BID #24-26-D04
Sitework and Structural for Downtown Campus
Addendum One
Released 11/26/2024

ADDENDUM: Addendum One addresses a process to request to be added to a prime/sub list for this project, questions and clarifications, a revised bid form, and drawings for DLC and DTC.

**Rock Valley College
New Downtown Campus
Sitework and Structural
Bid #24-26-D04**

Architect's Project Number: 23-030

SHEET NUMBER:
 S1.02

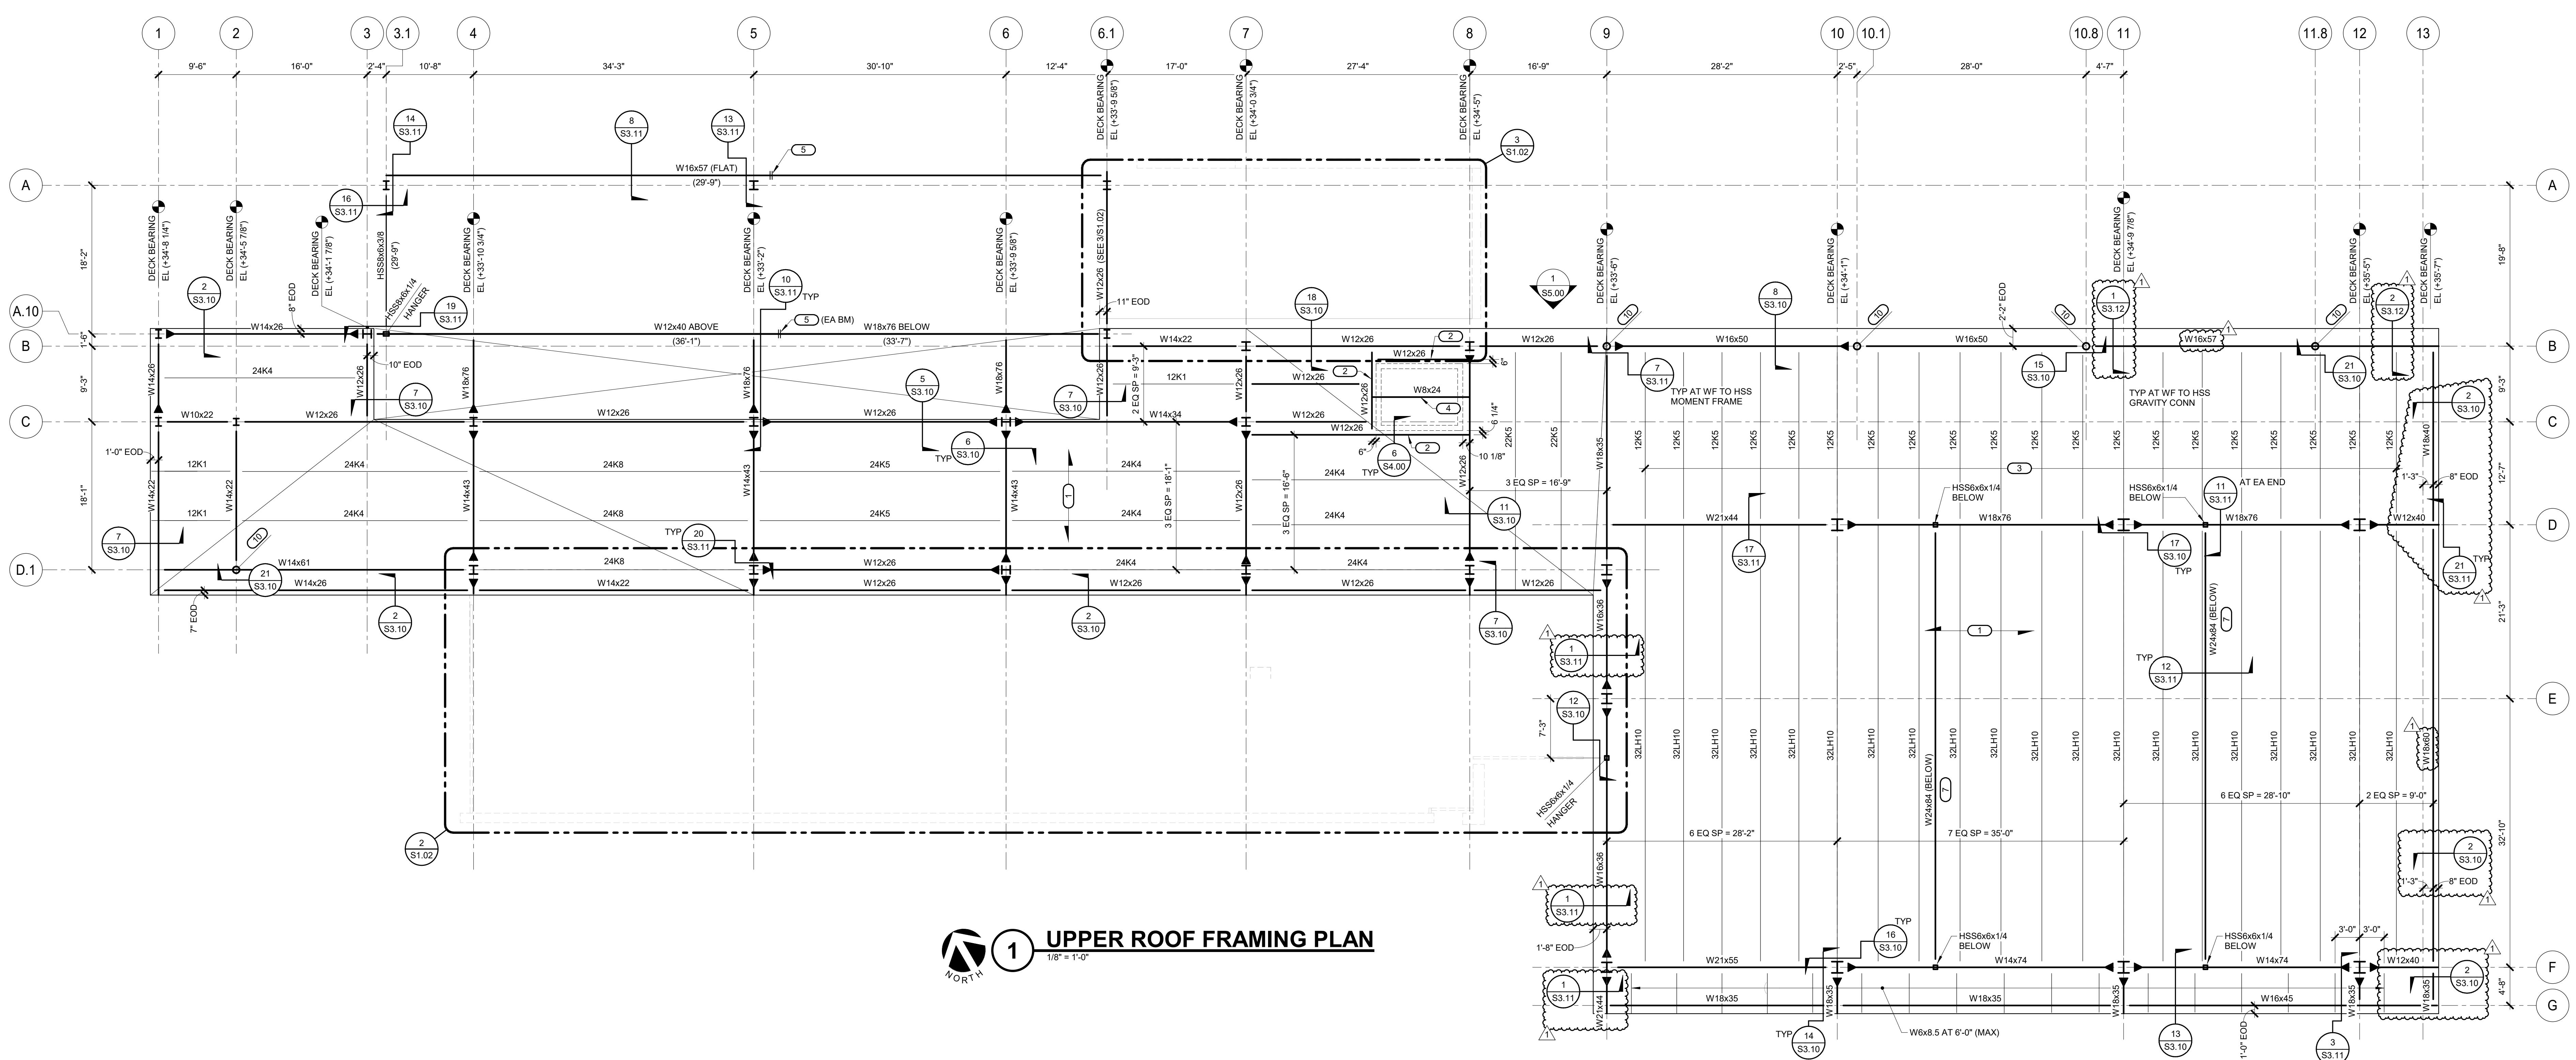
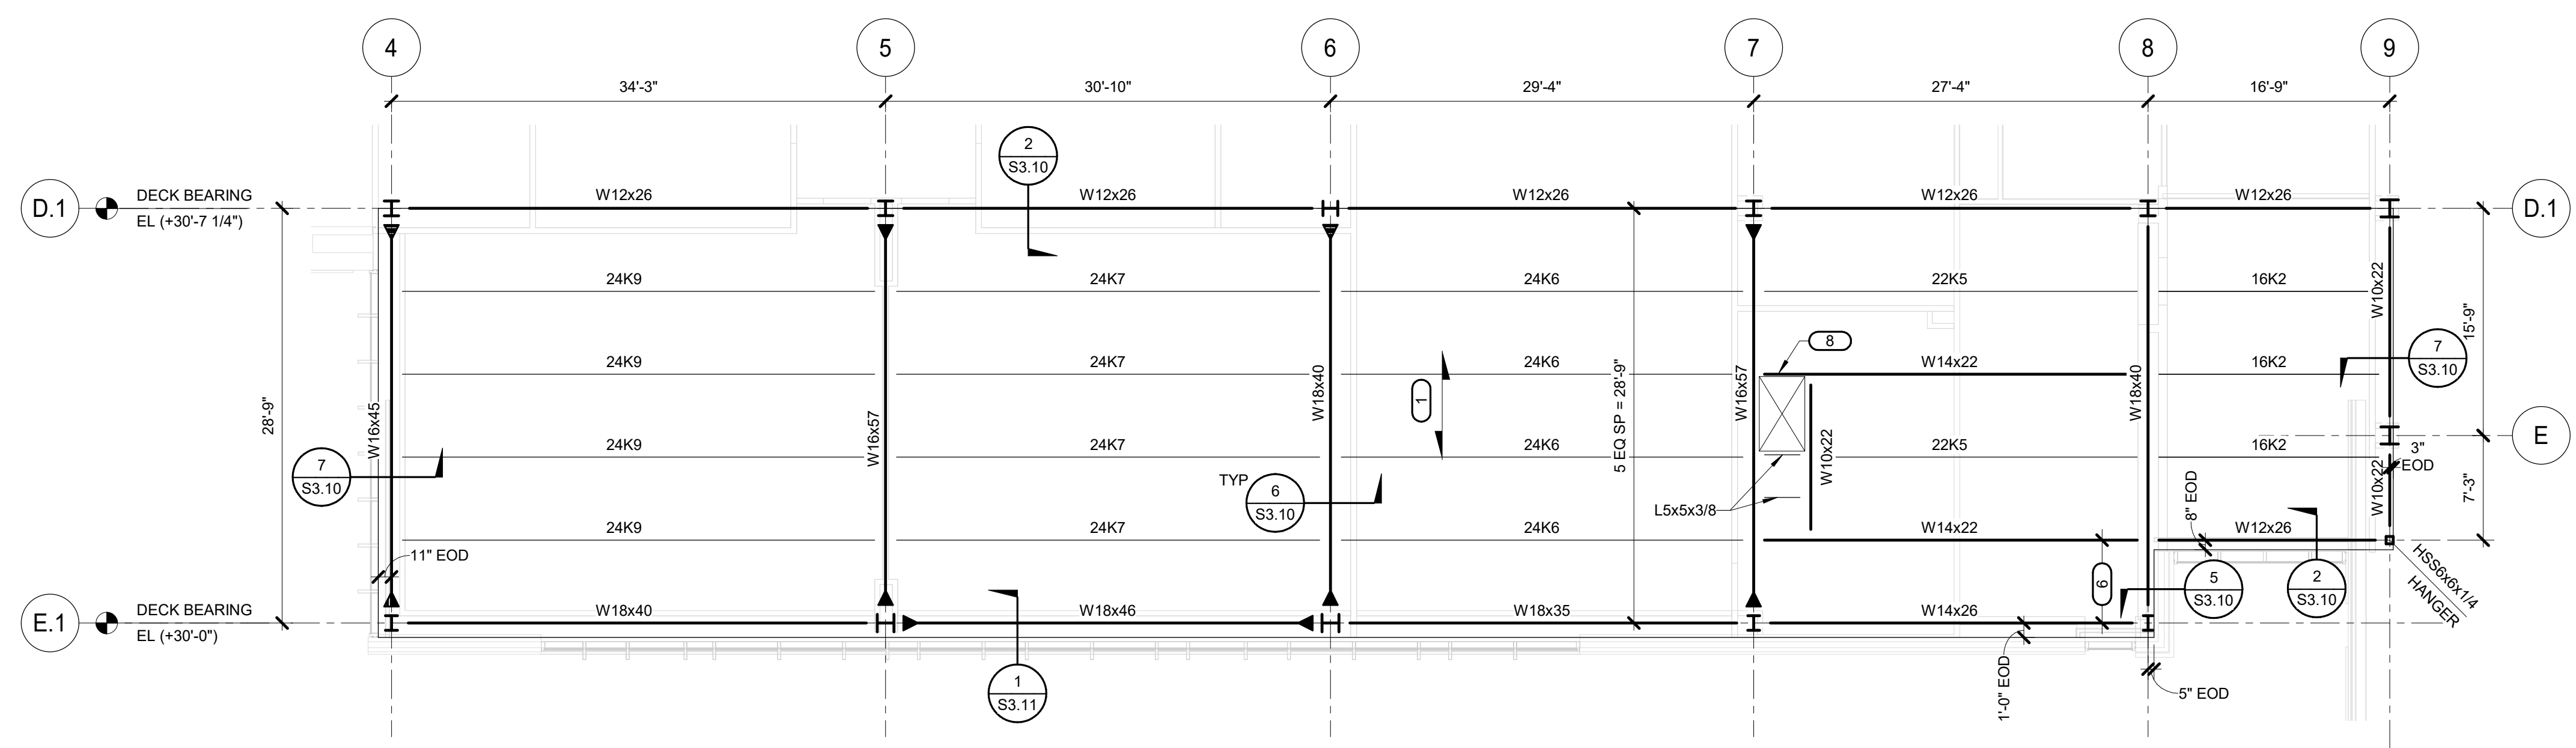
- C. Detail callout 10/S3.02 added where precast façade wall is supported by steel framing.
17. Sheet S1.02
 - A. Beam sizes and connection adjusted to fit architectural sections (along Grid 13).

9 FOUNDATION AT CURTAIN WALL
 3/4" = 1'-0"

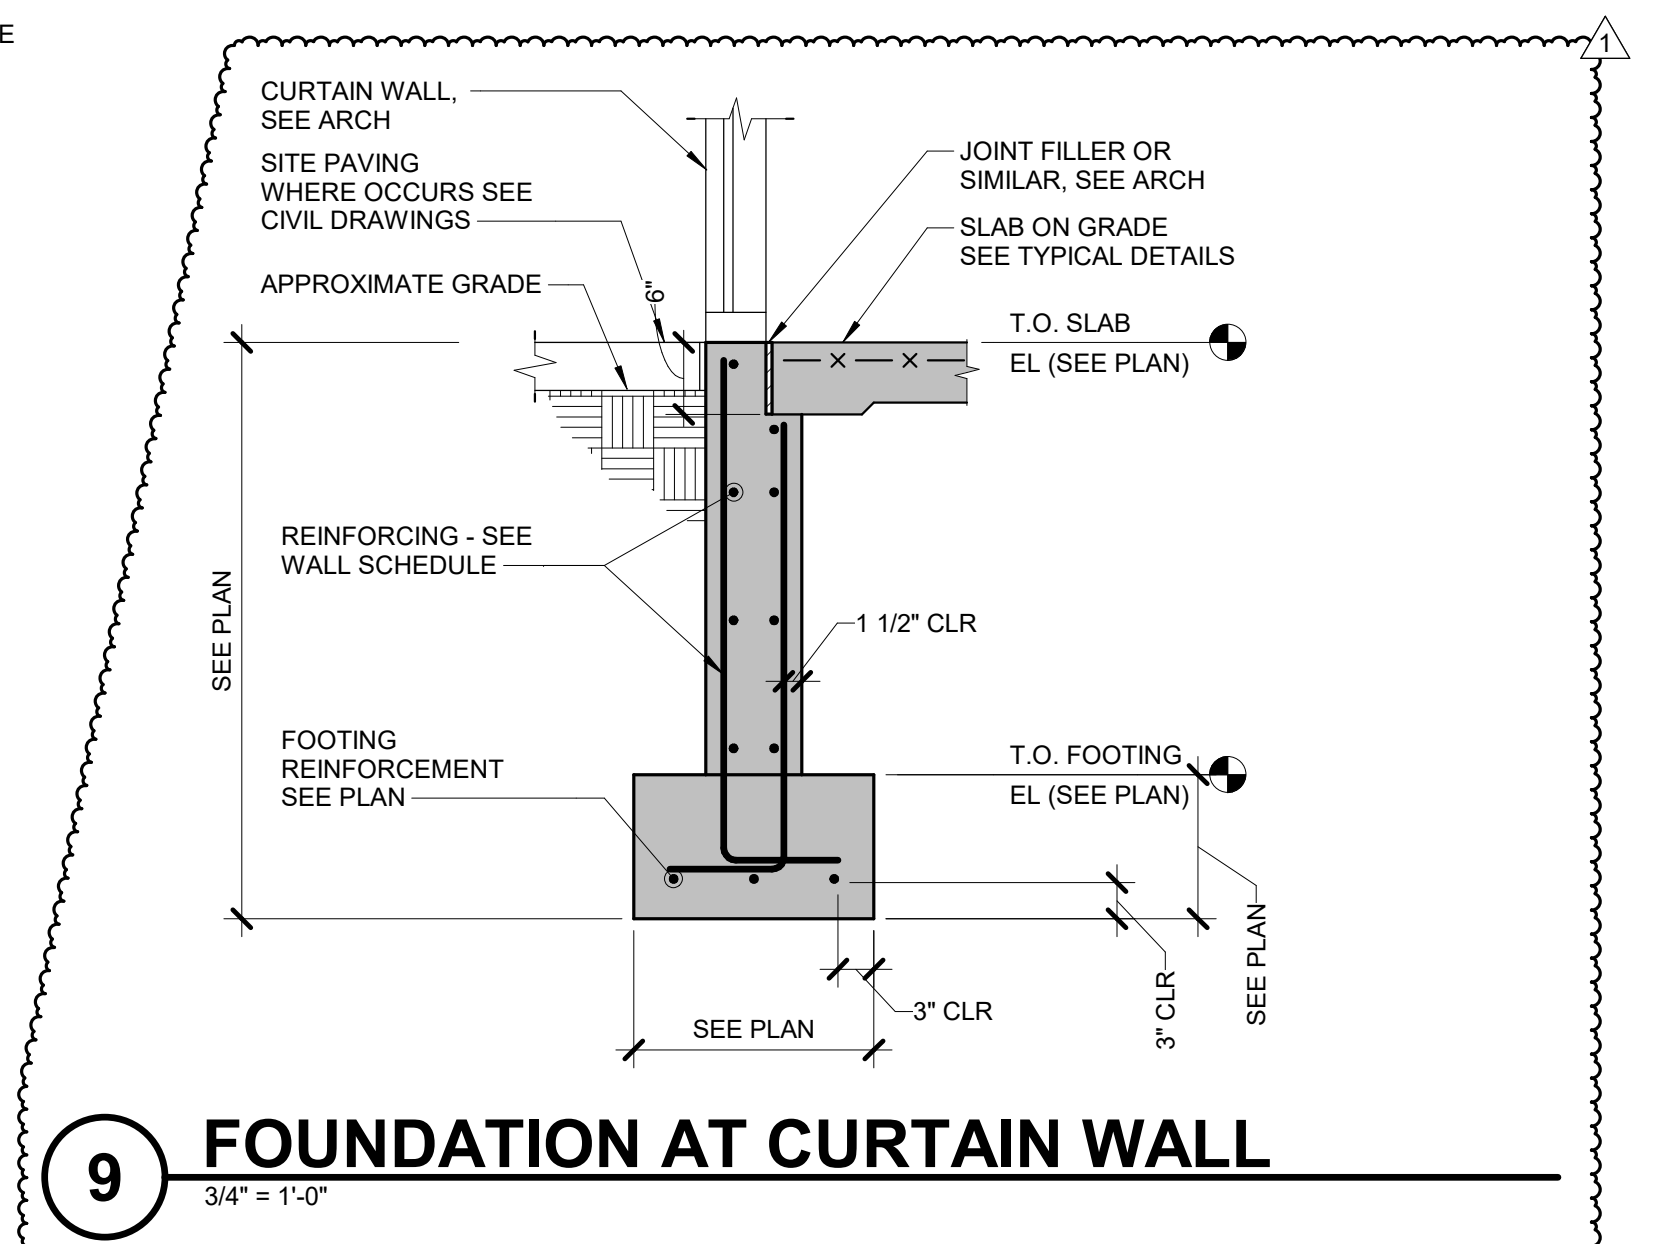
18. Sheet S2.00
 - A. Detail 9/S2.00 adjusted to alternative stem connection to avoid visual seam at base of curtain wall
 - B. Pier size and reinforcement adjusted at detail 10.

1 HSS COLUMN BASE PLATE
 3/4" = 1'-0"

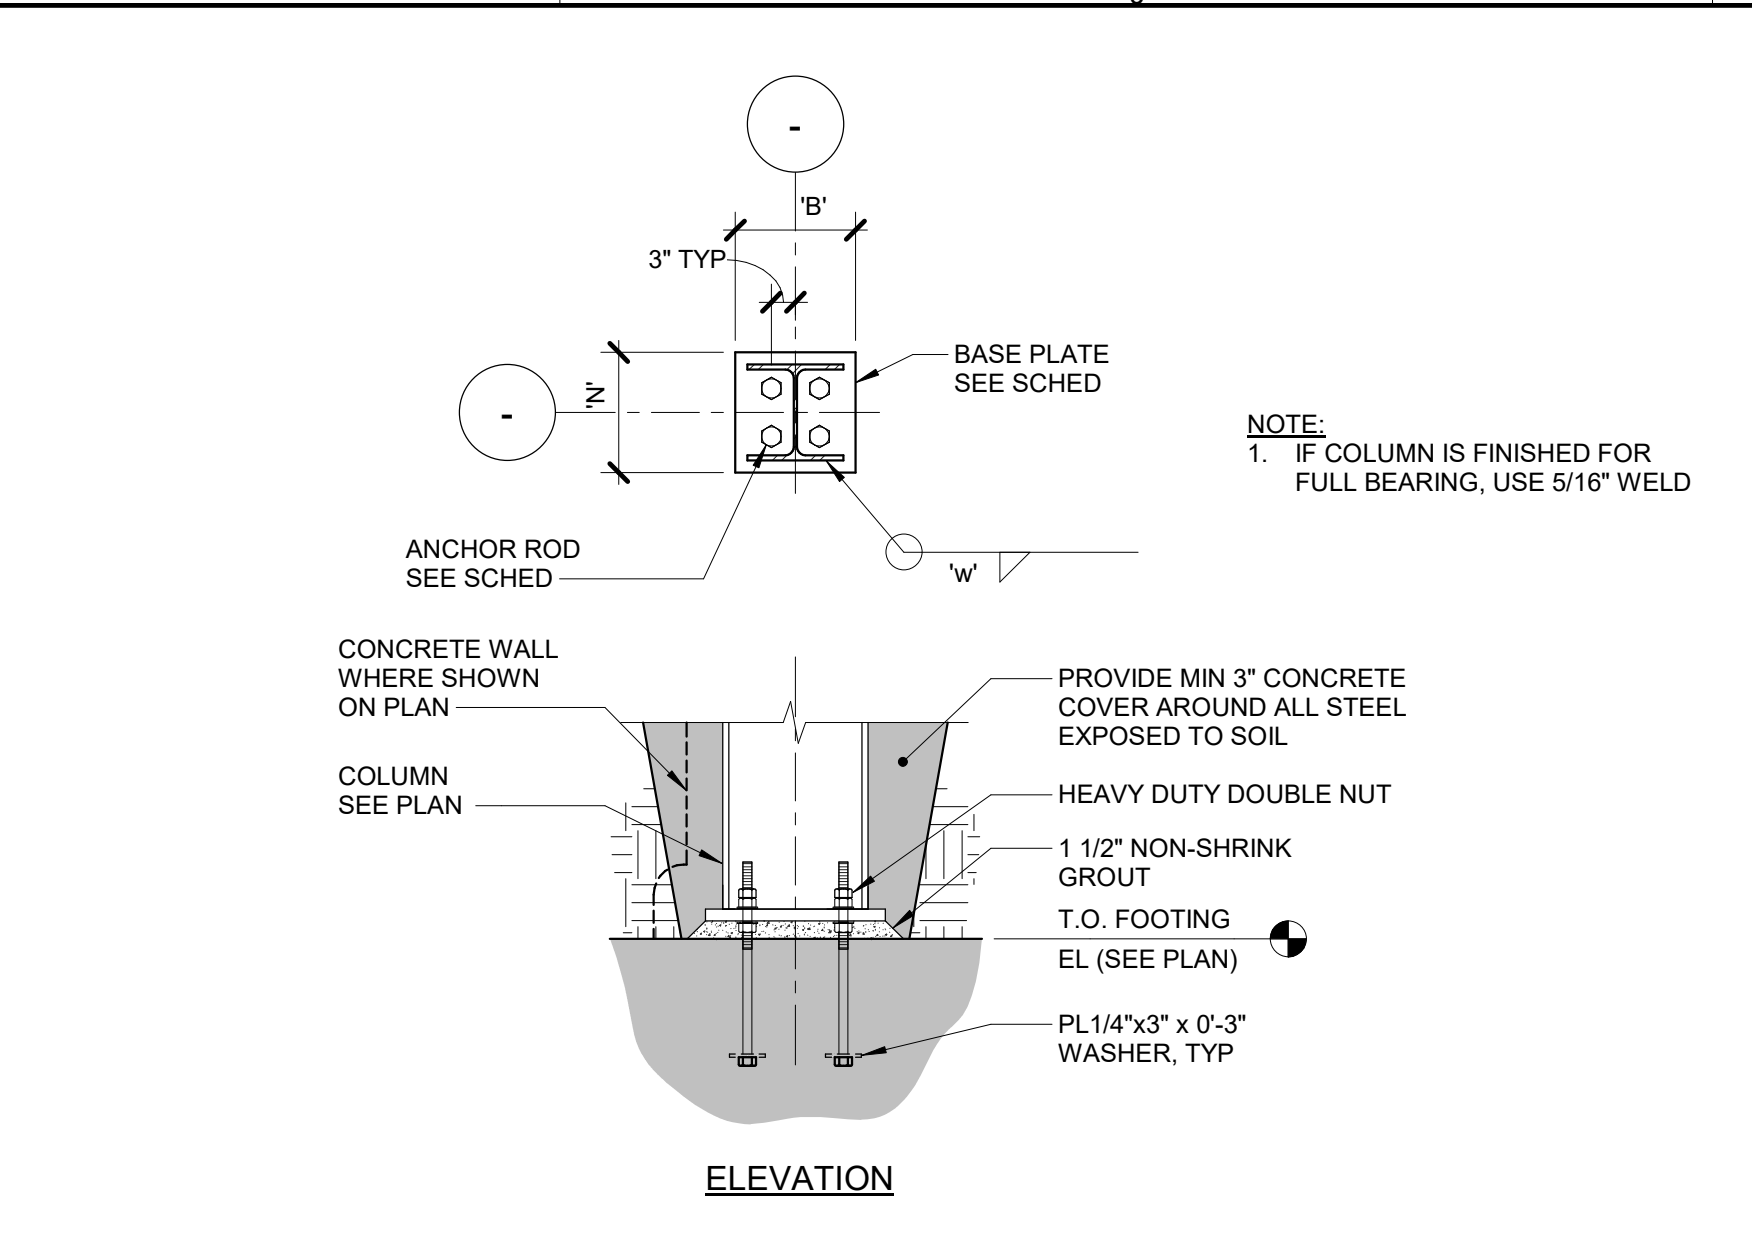
19. Sheet S2.01
 - A. Details 13 and 14 adjusted.
20. Sheet S3.00
 - A. Base plate schedules added to details 1 and 2.
21. Sheet S3.02
 - A. Base plate schedule added to detail 1.
